82545EM Gigabit Ethernet Controller Specification Update

June 6, 2006

The *82545EM* Gigabit Ethernet Controller may contain design defects or errors known as errata that may cause the product to deviate from published specifications. Current characterized errata are documented in this Specification Update.

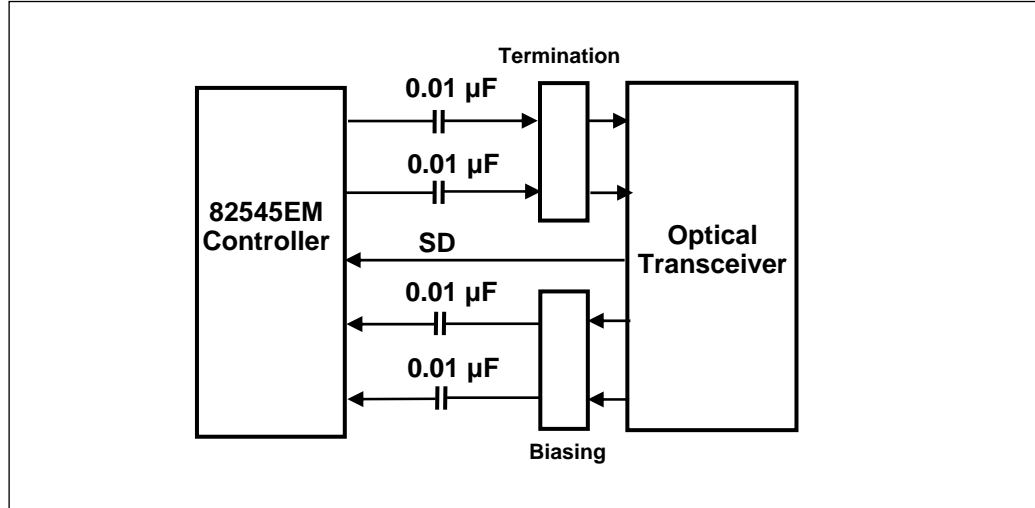
Problem: The schematics attached to this Specification Update supercede those in the original design guides. The schematics have not changed after the last Specification Update (0.5).

For the 82545EM Controller, the 0.5 revised schematic dated Sept. 24, 2001 is attached. This schematic did not change since the last Specification Update (0.6). Please note the following errors and omissions:

- The Gigabit Ethernet controller may be referred to as “Kenai 64”, “Anvik”, or “82546EB” on some of the sheets. The correct part reference is 82545EM.

- Some of the sheets refer to “Port 1.” Since the 82545EM controller is a single-port device, these references are irrelevant.
- The circuitry attached to the CTRL_15 pin requires modification for an erratum described elsewhere in this document.

- Ball A8 should be re-labeled as TEST# and have the pull-down resistor removed. This change is also described elsewhere in this document.

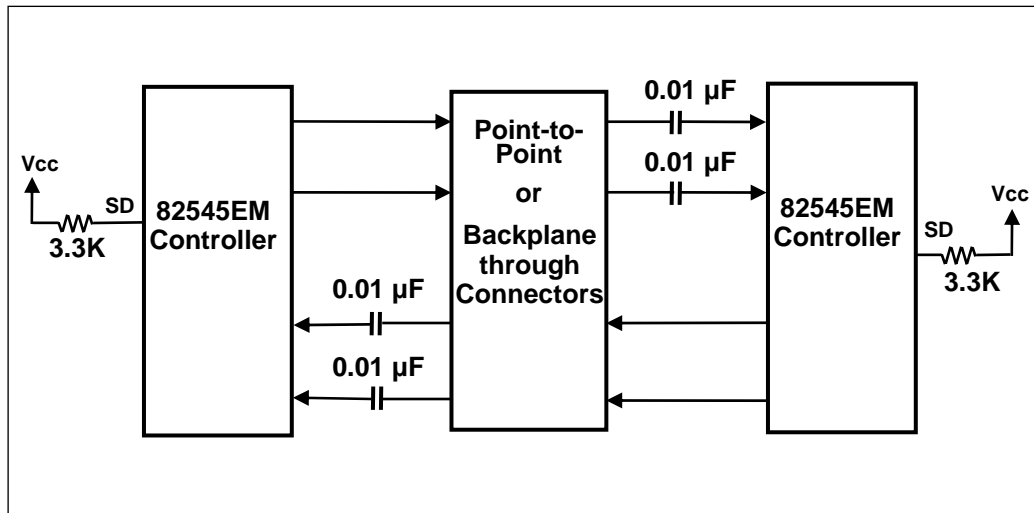
Problem: Intel added new SERDES functions to the 82545EM controller. SERDES stands for Serializer-Deserializer and is a circuit that converts Ethernet packet data from a parallel TBI format to a 1.25 GHz bidirectional serial stream. For 1000BASE-SX or 1000BASE-LX fiber applications, SERDES integration typically saves the designer the expense and board space of a 64-lead external device. The 82545EM controller contains one SERDES. A '10' needs to be written in ICW3 bits 1 and 0, respectively, in order to enable this feature.

The datasheet for the 82545EM Controller will change to define pins as follows:

82545EM controller fiber-based applications will use the SERDES interface to drive a 1000BASE-SX or 1000BASE-LX optical transceiver as illustrated in the above figure. The 82545EM controller is internally terminated, so no external termination is required.

Alternatively, the 82545EM may be used in short haul gigabit backplane data applications without transceivers and optical fibers. No special termination is required because the 82545EM device is internally terminated. The figure below illustrates a gigabit backplane or point-to-point circuit based on either the 82545EM device:
